Application No. 10/618,133  
Combined Amdt. And Response mailed April 15, 2005  
Attorney Docket No. ARA-US-P1

**AMENDMENTS TO THE DRAWINGS**

The attached sheet of drawings includes changes to FIG. 13. This sheet, which includes FIG. 13, replaces the original sheet including FIG. 13. In amended FIG. 13, previously omitted element numerals 600, 602, 604 and 606 have been added.

FIG. 13

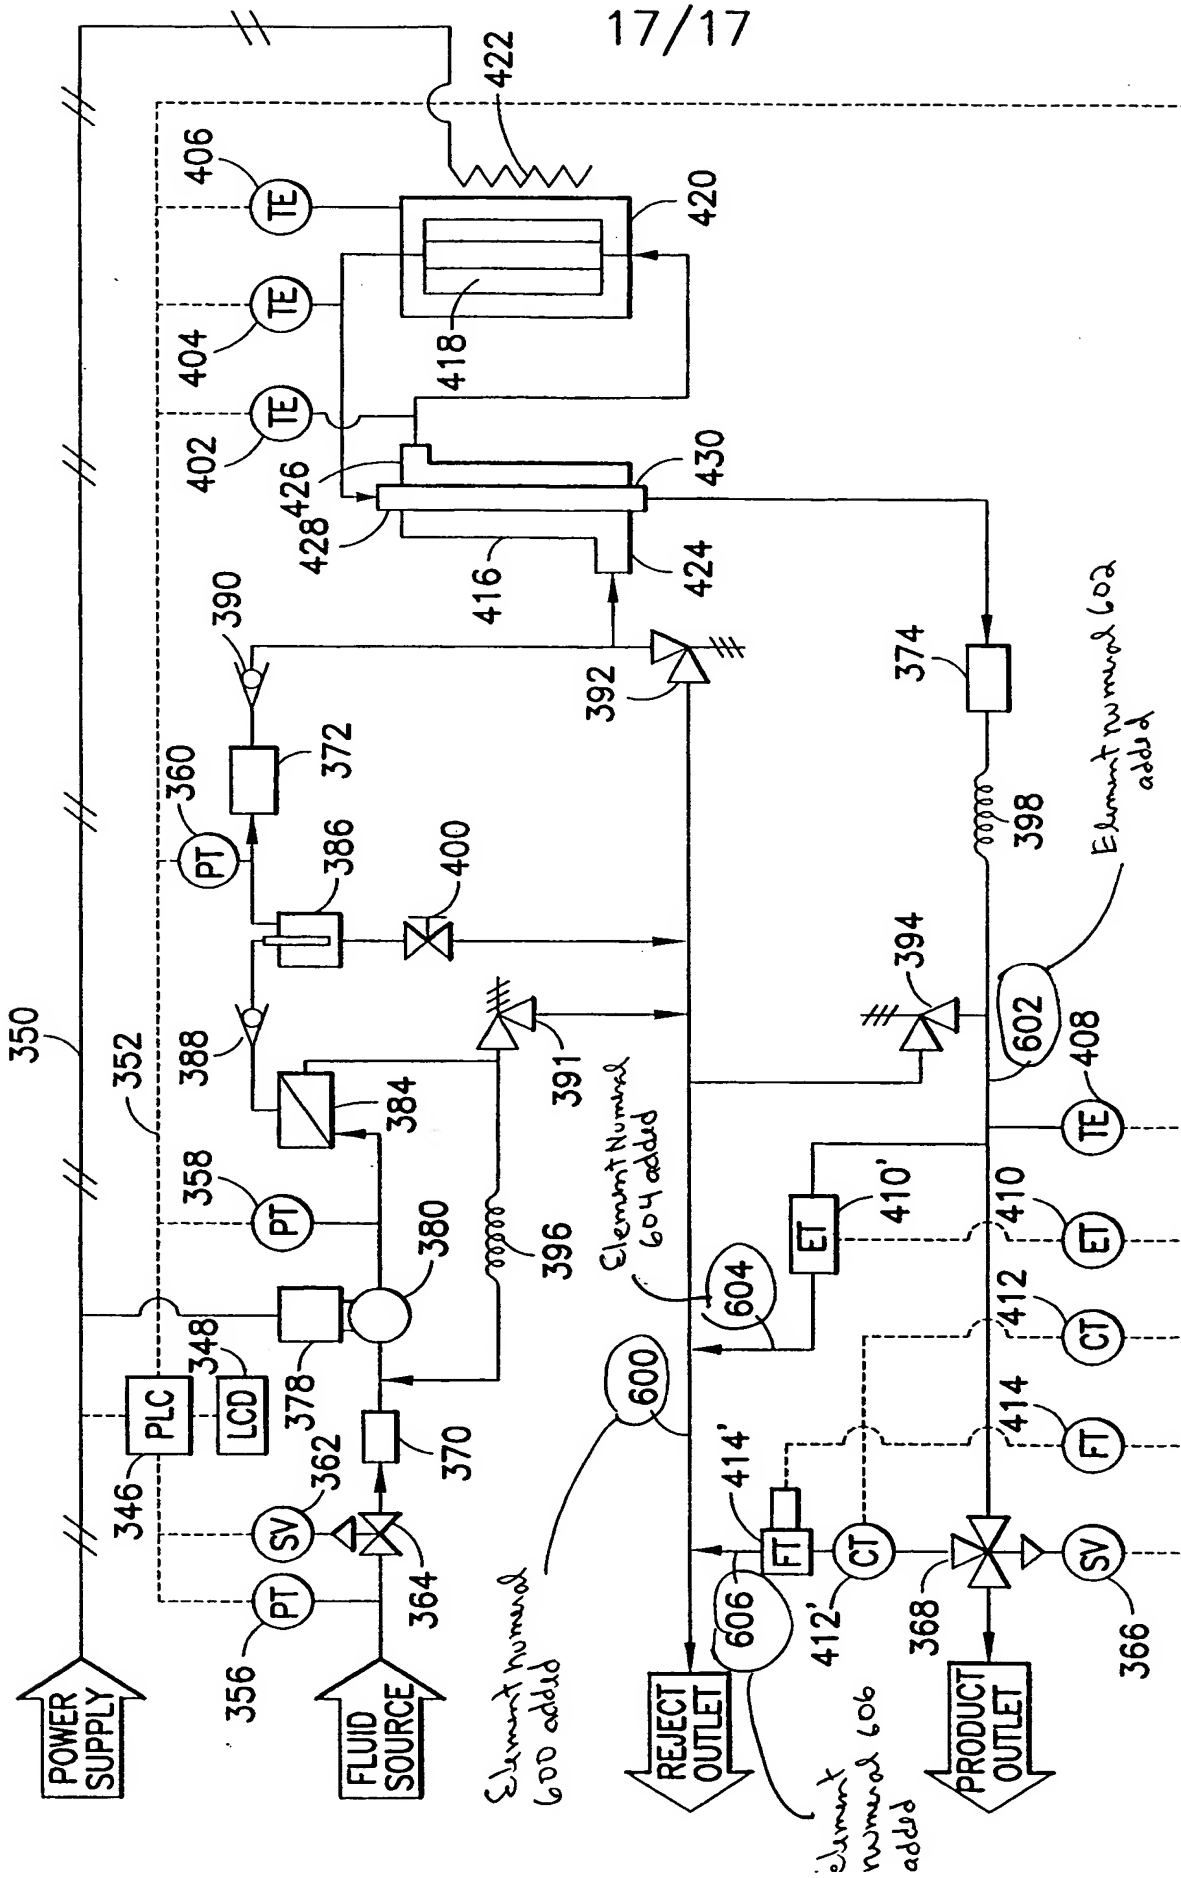
The paragraph at page 35, line 7-14 has been amended to account for the amendment of FIG. 13 (i.e., the addition of previously omitted element numerals 600, 602, 604 and 606) and also to make it clear that when pressure relief valves 391, 392, and 394 open, the fluid from each of these valves flows to a reject outlet via a reject line 600. Support for this amendment can be found in FIG. 13 which shows that the fluids coming from pressure relief valves 391, 392, and 394 flow into a line (element numeral 600 in amended FIG. 13). Further, FIG. 13 shows that line 600 goes to the reject outlet. Hence, line 600 is a “reject line”. No new matter has been added by this amendment. See, MPEP 608.04 (“In establishing a disclosure, applicant may rely not only on the specification and drawing as filed...”) (underscoring added). See also, MPEP § 2163 at II.A.3.(a), citing, *Vas-Cath*, 935 F.2d at 1565, 19 USPQ2d at 1118 (“drawings alone may provide a ‘written description’ of an invention as required by Sec. 112....”); *Autogiro Co. of America v. United States*, 384 F.2d 391, 398, 155 USPQ 697, 703 (Ct. Cl. 1967) (“In those instances where a visual representation can flesh out words, drawings may be used in the same

The paragraph at page 35, line 15-22 has also been amended to make it clear that a portion of the product fluid from the second flow restrictor 398 is diverted from the product line via a sampling line 604 to pass through an endotoxin sensor 410'. Support for this amendment can be found in FIG. 13 which shows a line (element numeral 604 in amended FIG. 13) leading away from product line 602 and going towards reject line 600. It is clear from FIG. 13 that line

604 diverts a portion of the product fluid flowing from the second flow restrictor so as to pass through endotoxin sensor 410' disposed along line 604. Since line 604 diverts a portion of the product fluid so that the endotoxin level of product fluid can be measured, line 604 is a "sampling line". No new matter has been added by this amendment. See above: MPEP 608.04; *Vas-Cath*, 935 F.2d at 1565, 19 USPQ2d at 1118; *Autogiro*, 384 F.2d 391, 398, 155 USPQ 697, 703; and *In re Wolfensperger*, 133 USPQ at 542 (CCPA 1962).

In amended FIG. 13, previously omitted element numerals 600, 602, 604 and 606 have been added. No new matter has been added by these amendments.
